# CONSIDER ALTERNATIVES TO VICROADS SHARED BIKE PATH PROPOSALS THAT ARE BETTER FOR OUR LOCAL COMMUNITY.

## WHERE SHOULD THE SHARED PATH BE LOCATED - MAIN STREET OR DIGGERS WAY?

Figure 1. VicRoads Main Street option

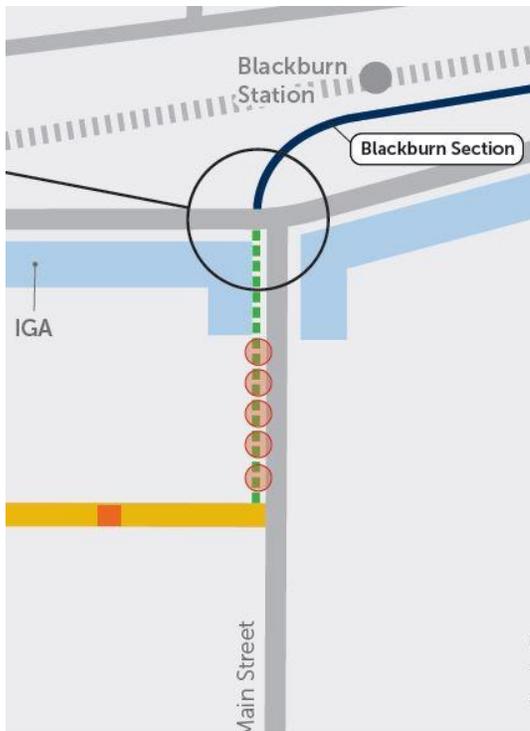
- Will replace the green nature strip with concrete and destroy 5 street trees at a time when Council are trying to increase tree canopy.
- Will put cyclists at risk of collision due to inadequate buffer to the pavement landscaping, street signage and opening car doors. The desirable 0.5m buffer to obstacles cannot be provided.
- Will put cyclists in conflict with pedestrians exiting parked cars to access footpath and customers wandering from shops to their cars.
- Will narrow roadway, which may result in congested traffic and complications for turning buses.
- Will pass the front entrance door of 9 commercial tenancies, 2 residential properties and 1 x 15-unit apartment building in 110m.

Figure 4,5 & 6. Exclusive bike path preferred proposal.

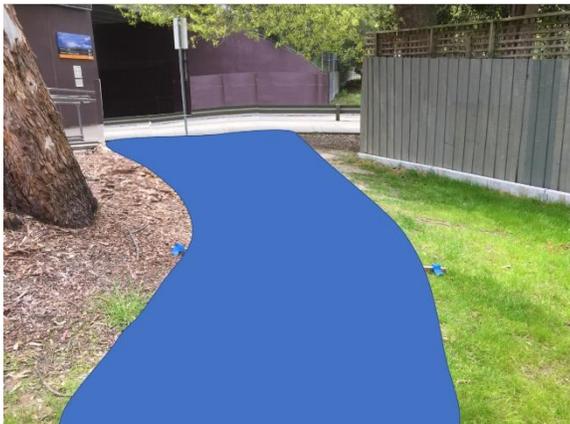
- Will be less intrusive, at 2m wide with a .5m buffer each side. VicRoads path is 3m wide + .5m buffer.
- Will closely align to the existing walking path, but existing path is not changed.
- Will maximise soil permeability for storm water infiltration and has less impact on Council drainage works at the low point.
- Will retain the open grass area for passive recreation.
- Will require minimal adjustments to the playground seating locations.
- Will cost less, be shorter and require less materials to construct than VicRoads version.
- Is supported by passionate local residents
